HISTORIC PRESERVATION COMMISSION

ALTERATION TO A HISTORIC PROPERTY STAFF REPORT

Site: 27-29 Meacham Road Edmund Sparrow House

Case: HPC 2016.089 Campbell Park/Meacham Road Historic District

BENEFITS TO REDESIGN OF RIGHT FIRE ESCAPE AT 27 MEACHAM ROAD

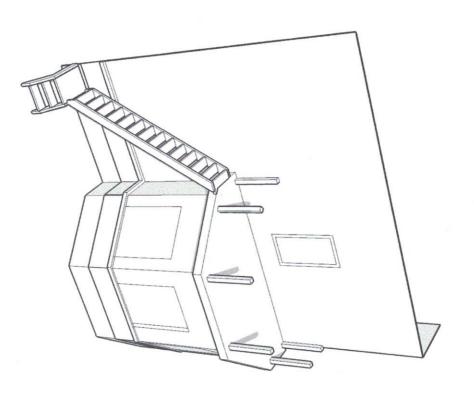
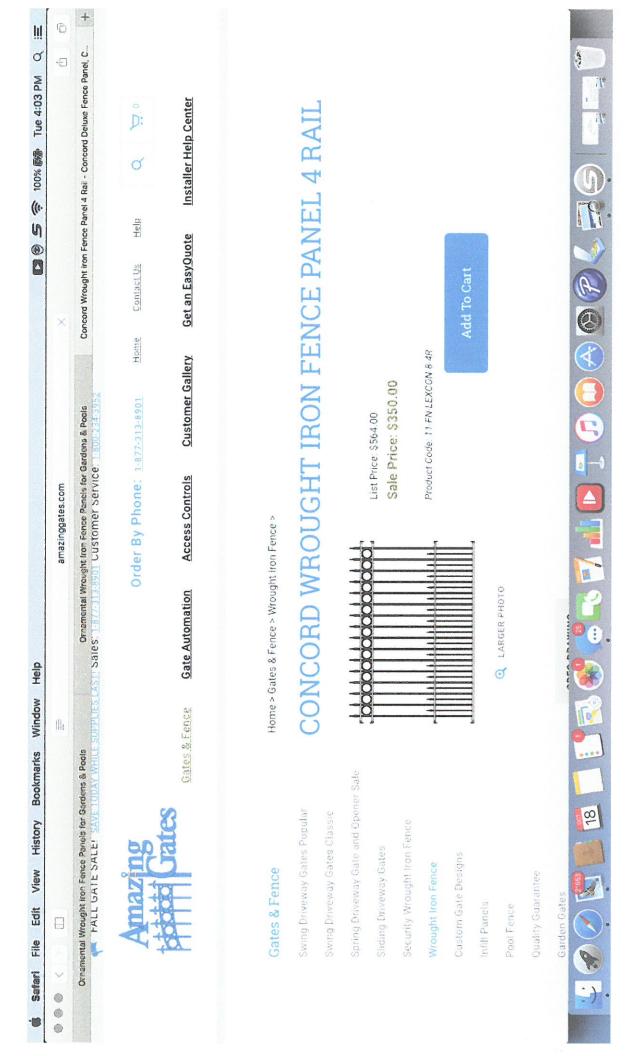
- reconfigured egress door would be in greater compliance with egress codes.
- redesign eliminates the steel "cat walk" which is damaging the historic bay

- reconfiguration of the staircase creating a landing brings the stair system into substantially greater compliance with current codes which require a landing every 12 feet.

- makes the whole stair system safer in that the stair changes directions, greatly reducing the possibility of someone being injured in an emergency situation by hitting the bay window.

- the redesign eliminates an awkward, tight, triangular shaped space between the stair system and the bay window and enhances the appearance of the front bay which has very beautiful brick detailing.

- the new stair system would be built out of wood, would be lighter and supported off the ground taking stress off the existing building and would be in an unobtrusive design plan with a streamlined wooden railing system, all of which would be painted the color of the body of the building, having minimal visual impact on the historic structure.

- 3. A deck shall be placed on the roof of the bay to evenly distribute the weight of the assemblage.
- 4. The deck shall be fenced with an inconspicuous simple rail, post and baluster system.

- 5. The egress stairs shall be reconfigured to descend from the side bay and turn away from the corner bay.
- 6. The window over the bay shall be replaced with a door with the same configuration and light pattern.
